**WARRANTY
BULLETIN**

WB14-08C

DATE :	MAY 2014	SECTION :	06 - Electrical
EXPIRATION:	MAY 2016		
SUBJECT :	GATEWAY MODULE REPLACEMENT

Figure 4

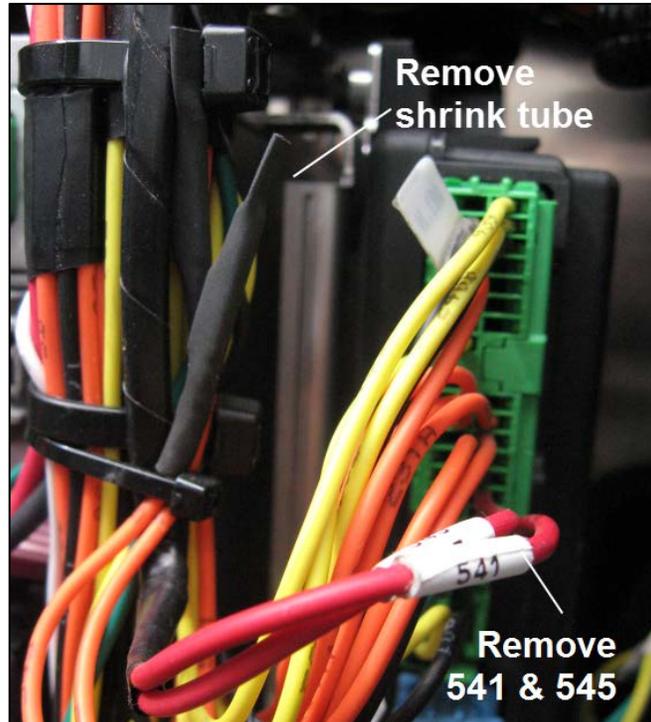
A4. Remove shrink tube and reconnect orange cables 541 and 545 from vehicle harness to VECU. (Fig 4)

- Connect 541 on JA1
- Connect 545 on JA2

Figure 11

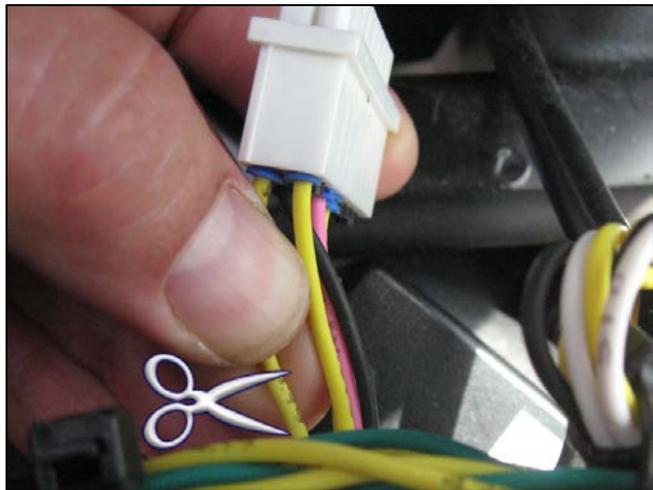
- C2. Unplug Connector to Gateway module A139.
- C3. Locate wire **439** at **pin 1** of Gateway Module A139. (Fig 11)
- C4. Cut about two inches away from connector. (Fig 11)

Figure 12

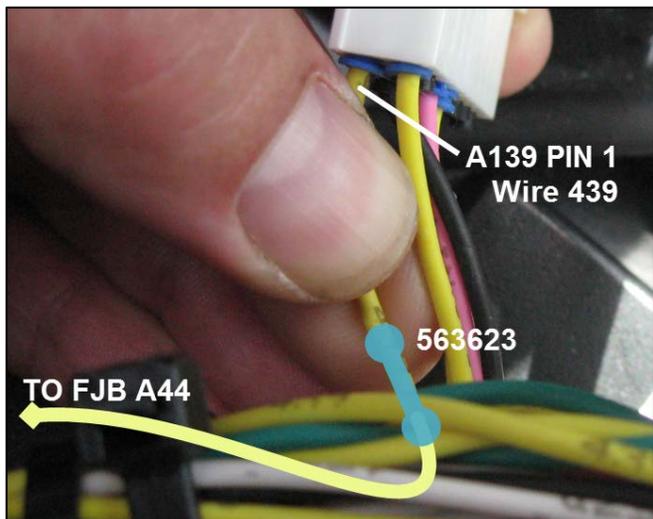
- C5. Run a new yellow 16ga **GXL** wire (560661 or equiv.) from A44 module in Front Junction Box to Gateway module.

Strip and connect to wire 439 coming out of gateway module connector pin 1 and new wire from front service compartment (FJB).

Use thermal shrink butt splice 563623. (Fig 12)

C6. Connect new wire to **A44:J1** using terminal 563692. (Fig 12)

Pin: 5 for H3-45 VIP and X3-45 VIP.

Pin: 6 for H3 BUS and X3-45 BUS
